EE SX Non Amplified Photomicrosensors (Transmissive) Change to Terminal Plating

PCN: PMS - 040
Ref No. 20260522_PDC_00003

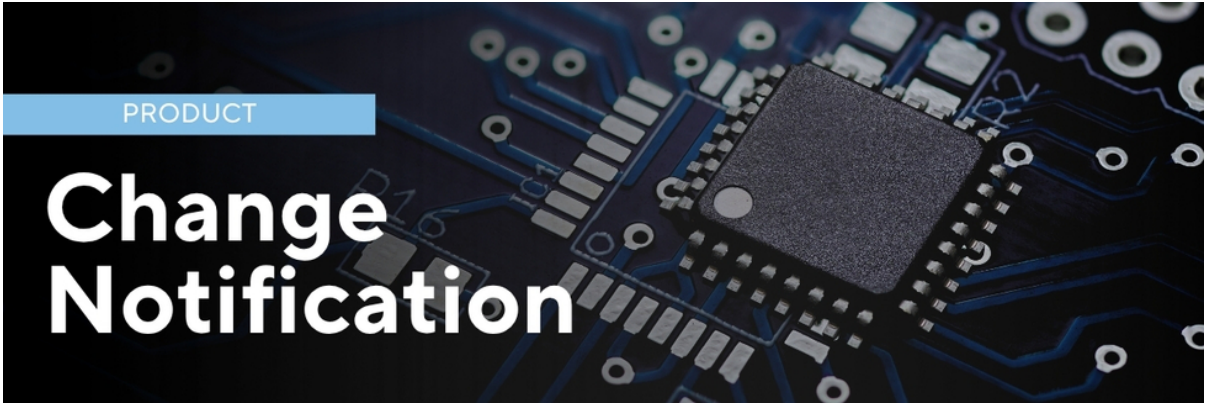
Before the change	After the change
Terminal Surface: Ag plating (Silver plating) 	Terminal Surface: Sn plating (Tin plating)  * No changes in soldering temperature and dimensions.
